Ser. No.10/564,929
Amdt. dated March 11, 2008
Reply to Office action of December 11, 2007

Remarks/Arguments

ANNOTATED SHEET SHOWING CHANGES

FIG.1

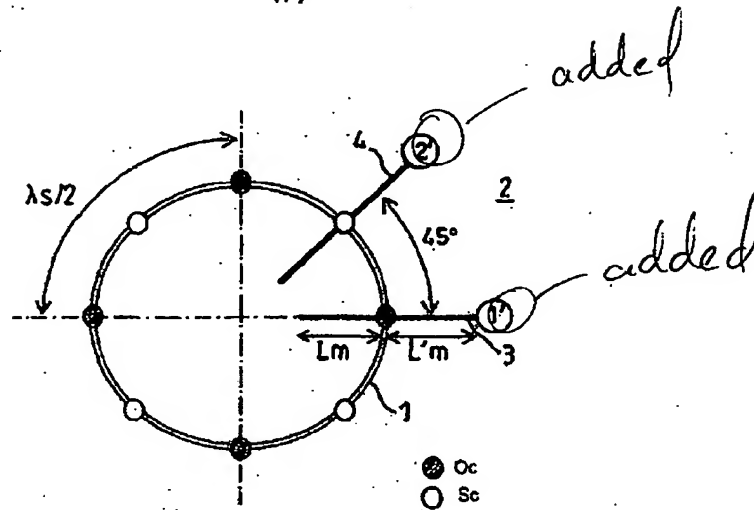
The Examiner has objected to the drawings under 37 CFR 1.83(a) as not showing every feature of the invention specified in the claims, specifically identifying "a planar antenna," "a substrate," "a short-circuit plane," and "a line/slot coupling." Examiner also objected to the drawings under 37 CFR 1.84(p)(4) due to use of the reference character 1 for both "slot" and "access" and the use of reference character 2 for both "access" and "substrate."

Applicant notes that the phrase "line/slot coupling," objected to by Examiner, has been replaced with "line/slot transition" in the amended claims. The slot is labeled '1' in figure 1. The feed line is labeled '3.' The "line/slot transition" is therefore represented in figure 1 where the representation of the slot 1 crosses the representation of the feed line 3. The phrase "short circuit plane," objected to by Examiner, has been removed from the amended claims.

Regarding Examiner's objection regarding representation of "a planar antenna," Applicant respectfully notes that the specification on page 3, lines 28-30, states, "As shown in figure 1, the planar antenna is constituted by an annular slot 1 realised on a substrate 2 by engraving on a ground plane that is not shown." As such, Applicant believes that "a planar antenna" is shown in amended figure 1 based upon the representations of the substrate and the annular slot from which the planar antenna is formed in the amended figure.

References for the first "access" have been changed to 1' in the amended figure 1 and the amended specification. References for the second "access" have been changed to 2' in the amended figure 1 and the amended specification.
